Administrative Office of the Courts

Amendment #2 Request for Proposals Project # K20-0072-82 Allegany County District Court Security Upgrade

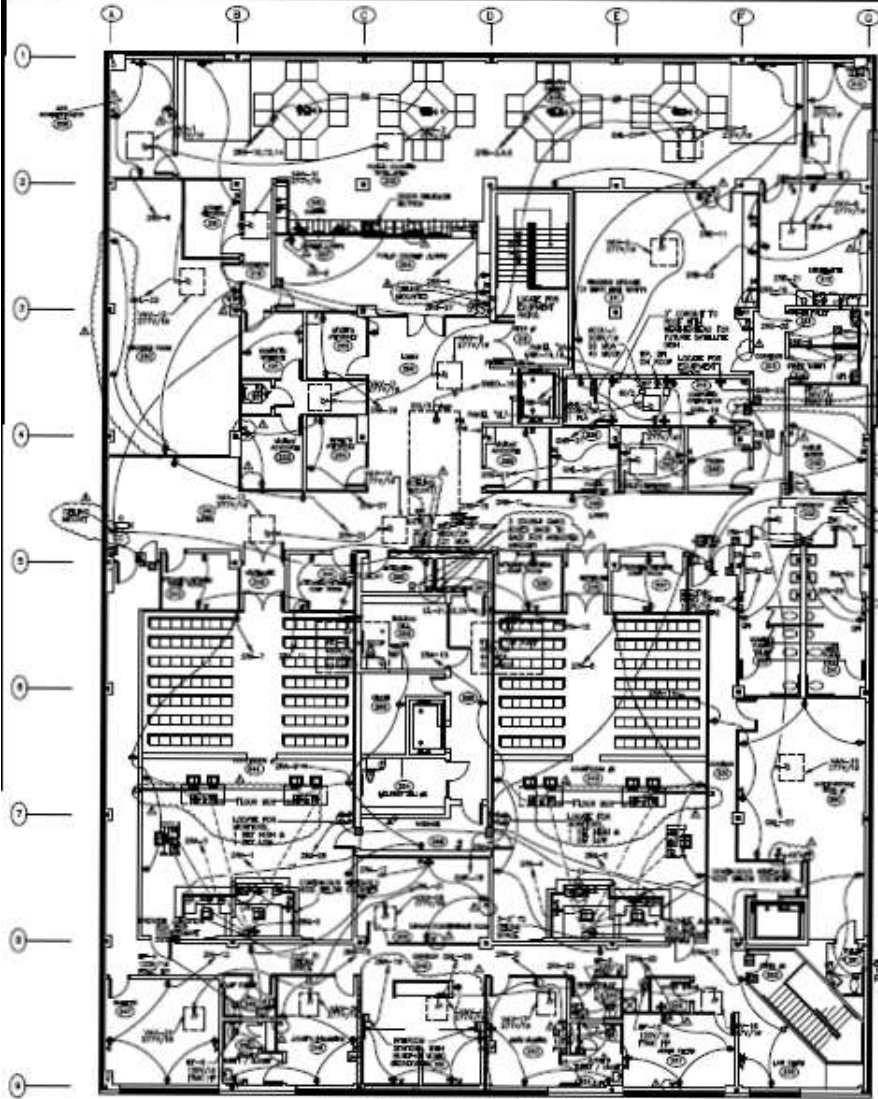
Add one additional HID card reader to the original proposal bringing the total count to 19. The additional HID card reader will be placed on an existing pedestal leading to the sally port.

SECOND FLOOR PLAN - POWER

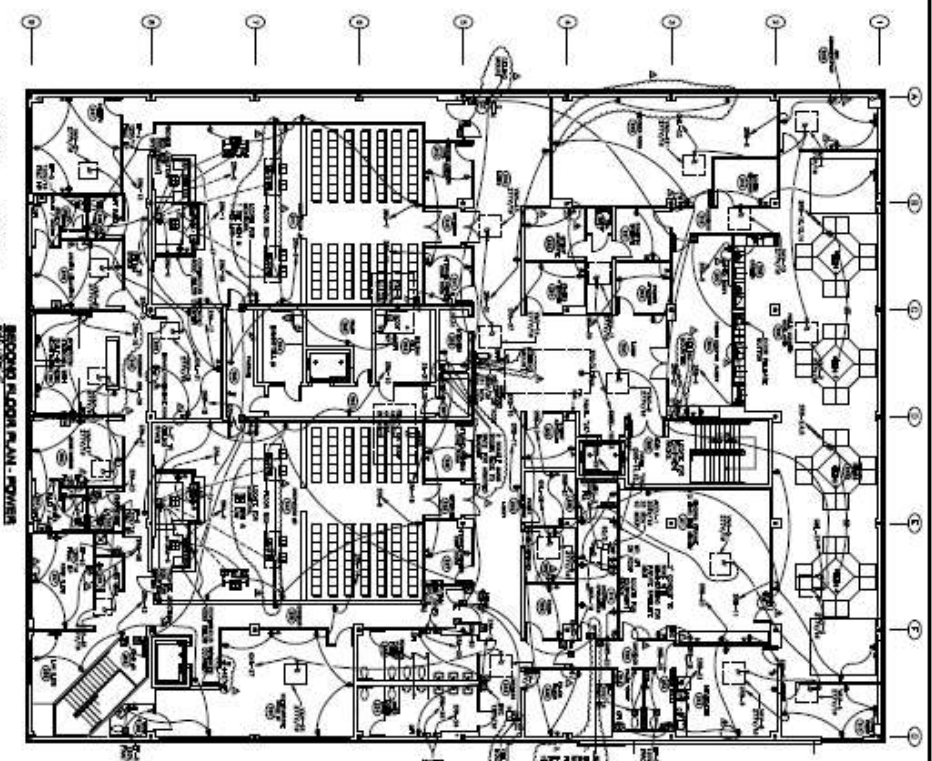
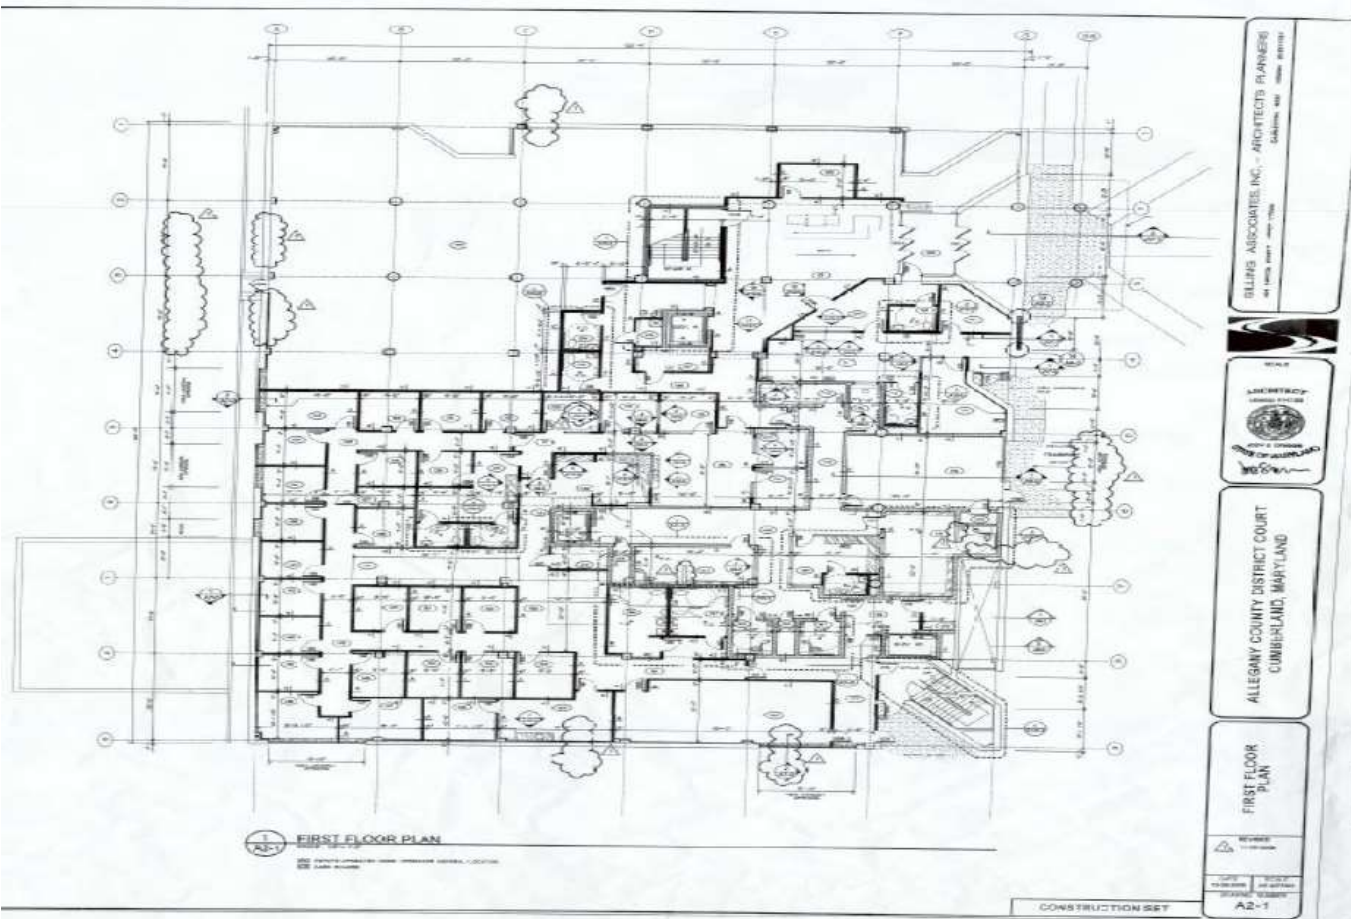
2. Include the following drawings:
